CERTIFICATE OF APPROPRIATENESS

Proposal: Alteration – Window, Stucco, Doors, and Siding:

HPO File No. 2025_0179

7907 Glen Prairie

PROPOSED STUCCO

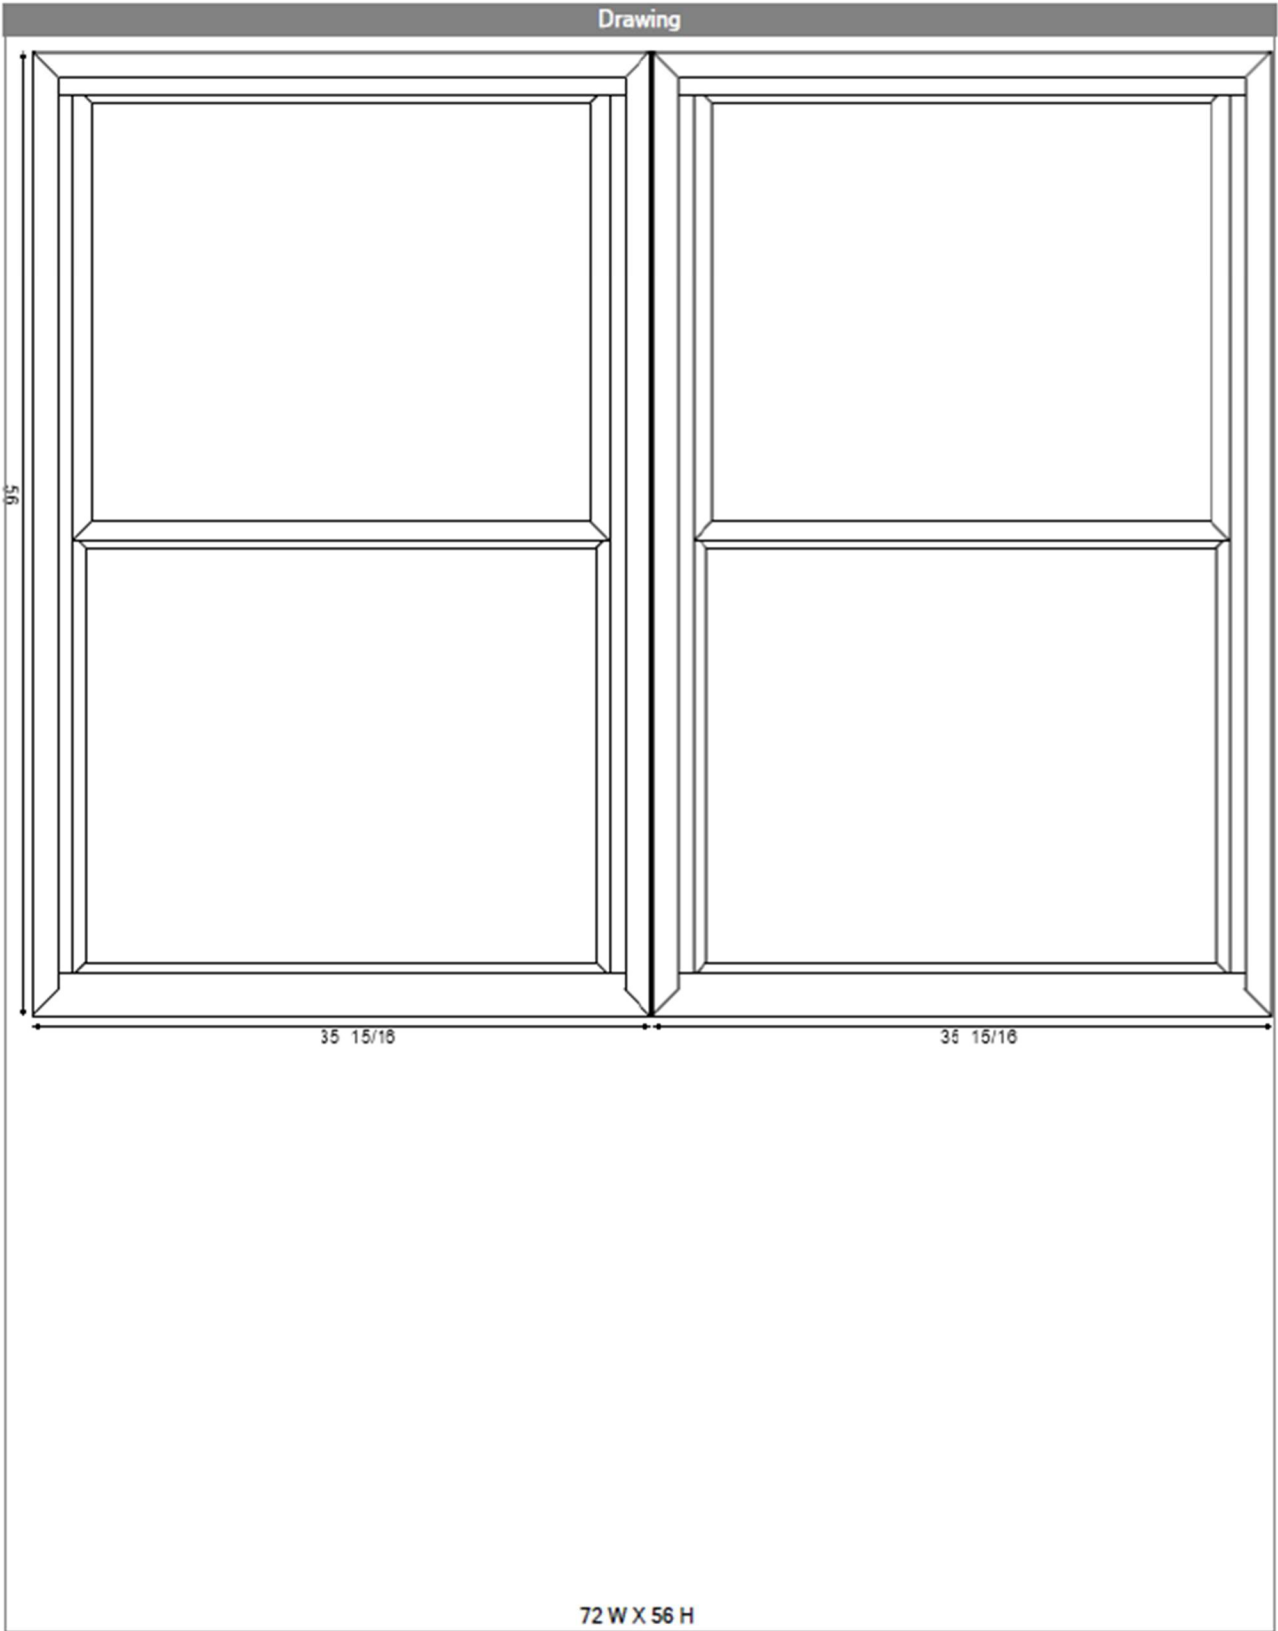
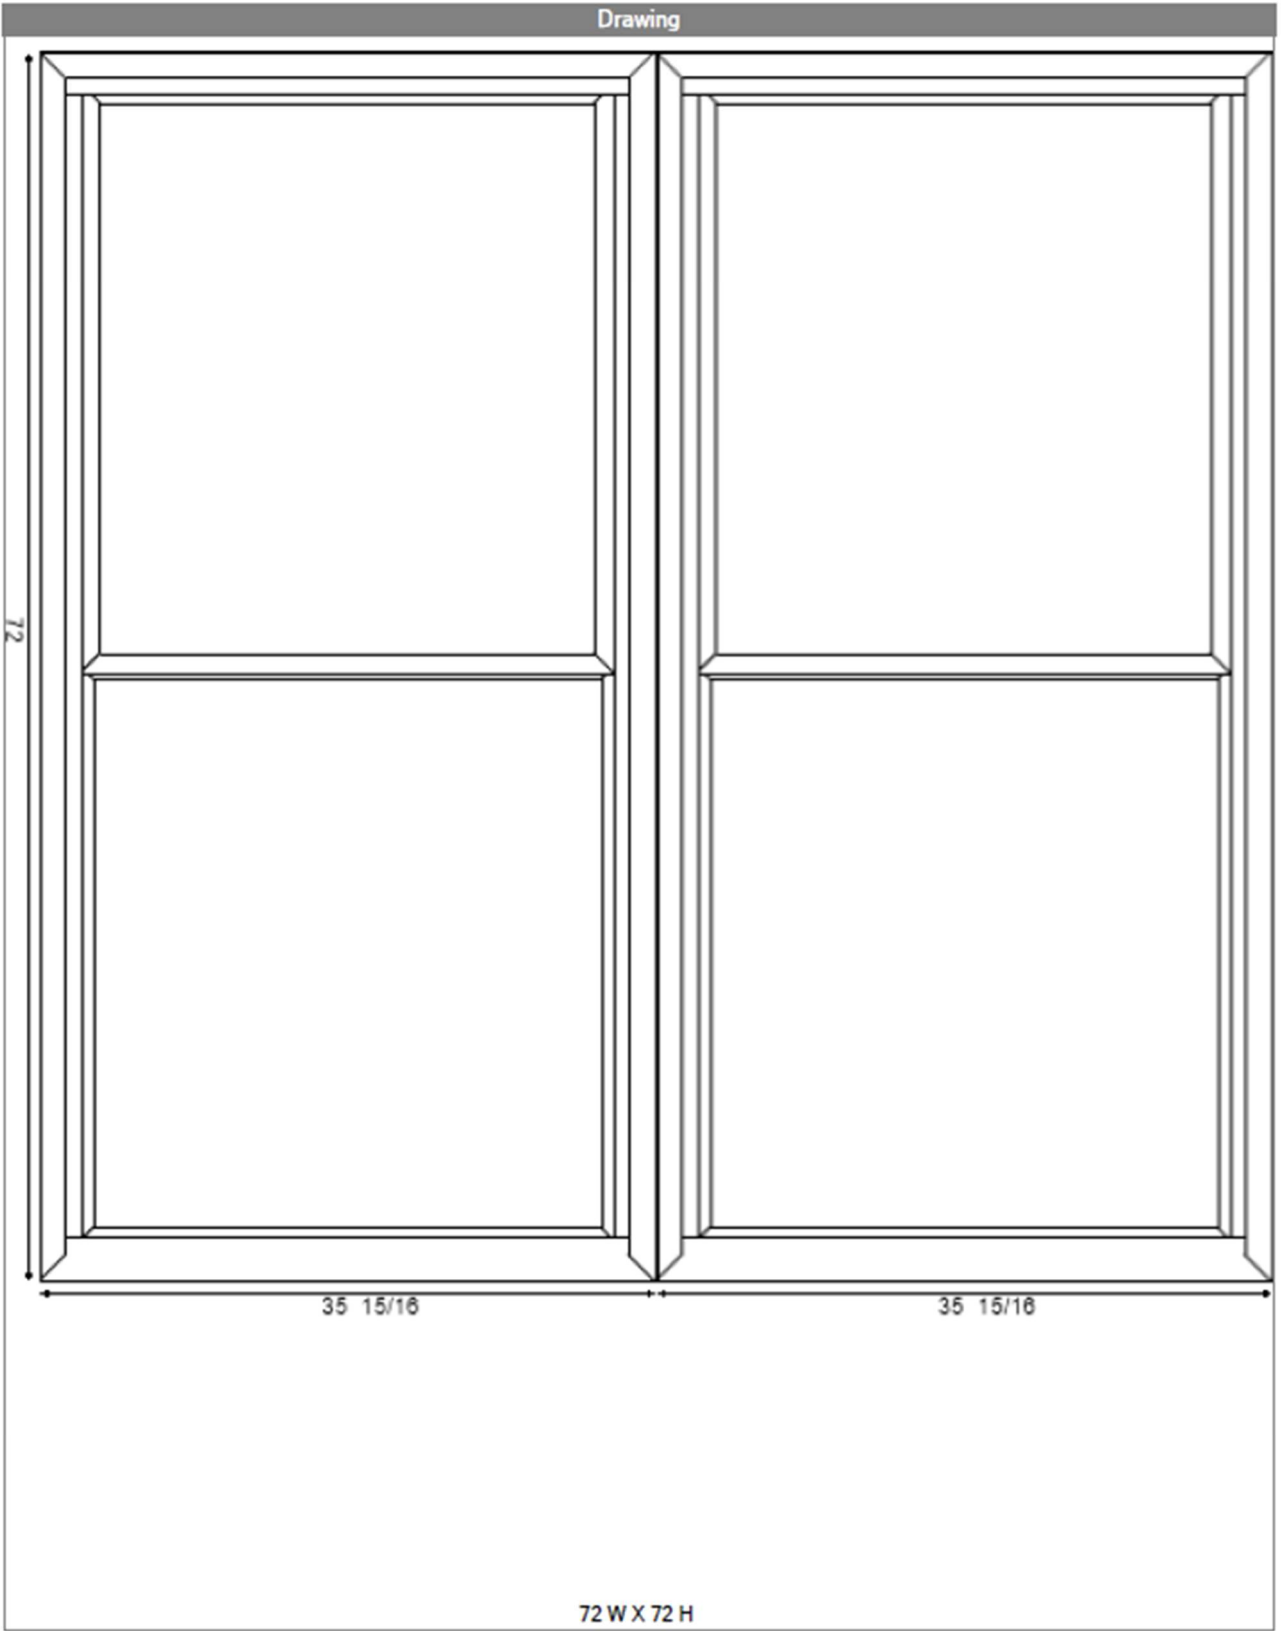
That the project be constructed with the proposed stucco option two, the proposed cementitious siding must be the same dimensions as the existing siding, and the proposed door to be discussed by the HAHC.

(b) The proposed activity must match the architectural features, materials, and character of either the existing noncontributing structure or the contributing structures within the context area.
The proposed stucco does not match the architectural features, materials, or character on any contributing structures in the context area.
